ADDENDUM NO. 3

April 3, 2014

KCCS Central Middle School – Bid Package 'A'

Dover, Delaware 19904

A-702

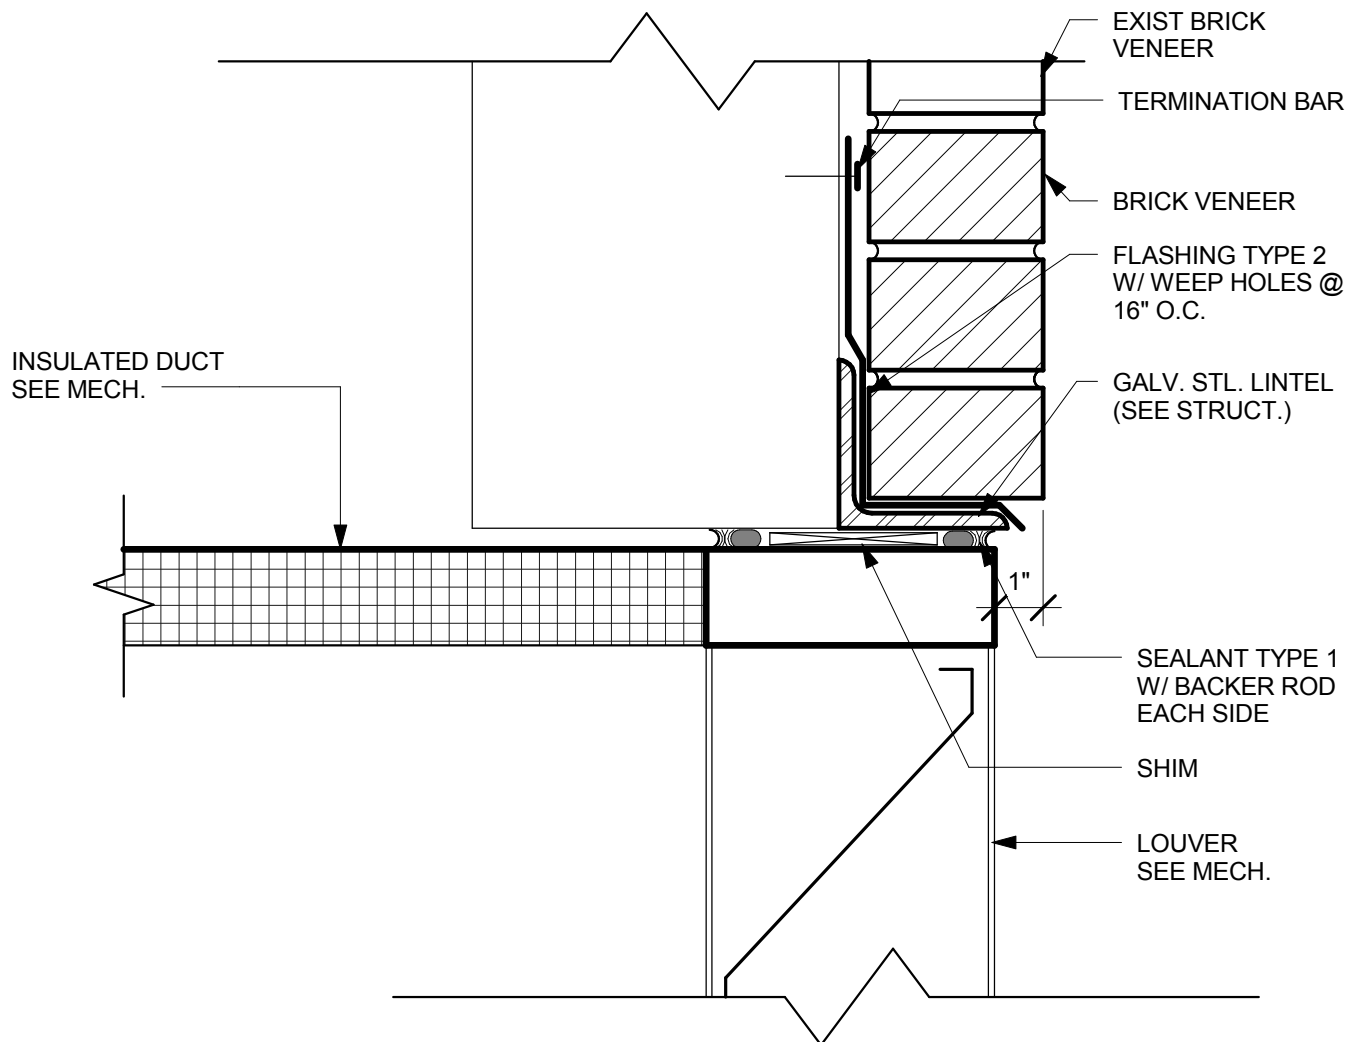
- Add Drawing A-701: DOOR TYPE C
- Add Drawing A-702: LOUVER TYPE 1
- Add Drawing A-703: LOUVER TYPE 1 - HEAD DETAIL
- Add Drawing A-704: LOUVER TYPE 1 - JAMB DETAIL
- Add Drawing A-705: LOUVER TYPE 1 - SILL DETAIL
